FAIRFAX COUNTY PLANNING COMMISSION

PUBLIC HEARING FOR PLANNING DETERMINATION

Application Number: **456A-M83-21-3**

Proposed Use: Fairfax County Police Department's Pine Ridge Police Operations Support Bureau.

Exhibit 2

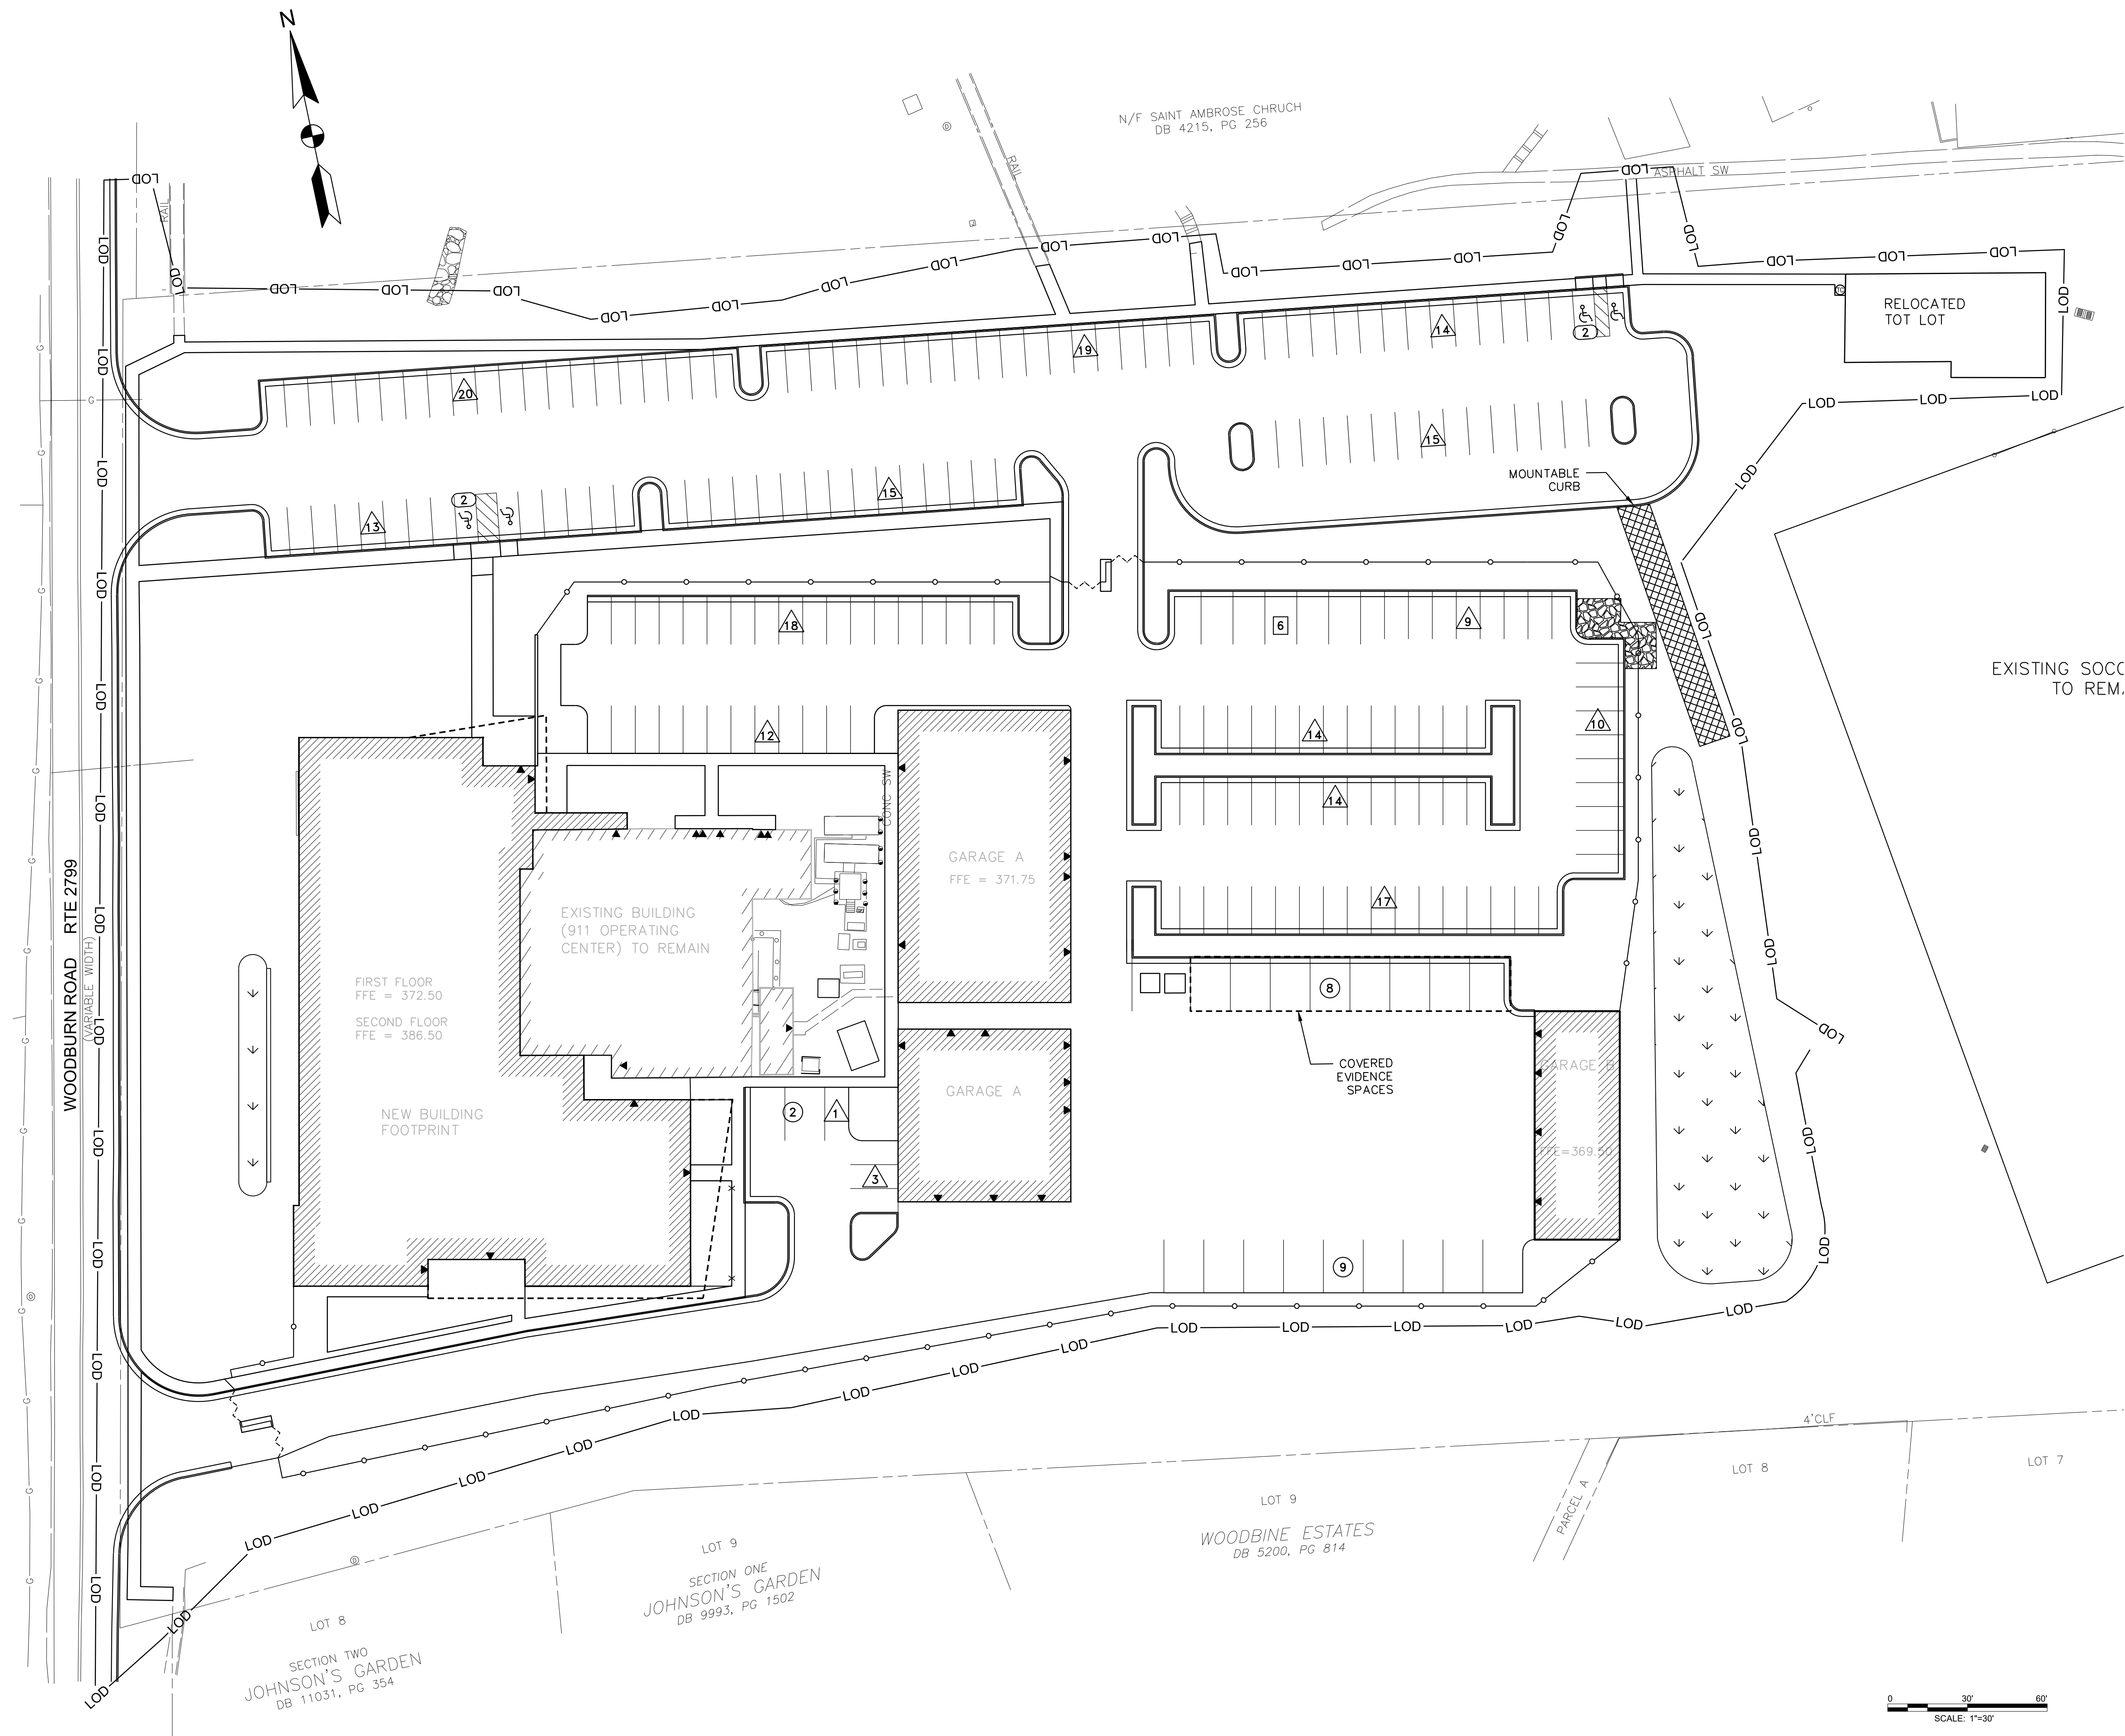
2. Comment: It appears that Transitional Screening Type II is required on the west, east and south sides of the site, while Type I is required on the northern side of the site. Since the plan is in a digital format that cannot be scaled, it is unclear if these full widths have been provided

3. Comment: It appears that a portion of the sidewalk along the northern side of the site, as well as the sidewalk along the western side of the site appear to be running parallel within the transitional screening areas, which would preclude planting within those

portions. Transitional screening areas cannot be occupied by any hardscape that would preclude planting such as sidewalks.

4. Comment: It is unclear if a combination of existing and proposed vegetation will be used to meet the transitional screening requirement, since nothing has been depicted within these areas. It is also unclear if a barrier D, E, or F will be provided within the western, eastern and southern transitional screening areas, or a barrier A, B or C provided within the northern transitional screening area, since they have not been depicted with a key and symbol. It should be known that transitional screening and barriers cannot be modified with the 2232 application process and will require a WTSW to be provided under a separate cover during the submission of a site plan for the site.

Recommendation: At a minimum, a note should be added specifying that transitional screening and barriers will be provided in accordance with article 13 of the Zoning Ordinance at the time of site plan on the 2232 plat.

6. Comment: It is unclear how the interior parking lot landscape requirement will be met for the site. The PFM clearly states that parking lots with 20 or more spaces shall provide interior parking lot landscaping information.

Response from Applicant: Transitional Screening requirements will be addressed with the permit plan submission.

Response from Applicant: Transitional Screening requirements will be addressed with the permit plan submission.

Response from Applicant: Landscaping will be provided as appropriate in the overall site development plan. Traditional screening yards and barriers, tree protection measures and perimeter erosion control measures will be provided in accordance with the requirements of the Zoning Ordinance and the Public Facilities Manual (PFM). This is stated in the 2232 application Statement of Justification section C item 4.

Response from Applicant: Landscaping will be provided as appropriate in the overall site development plan. Traditional screening yards and barriers, tree protection measures and perimeter erosion control measures will be provided in accordance with the requirements of the Zoning Ordinance and the Public Facilities Manual (PFM). This is stated in the 2232 application Statement of Justification section C item 4.
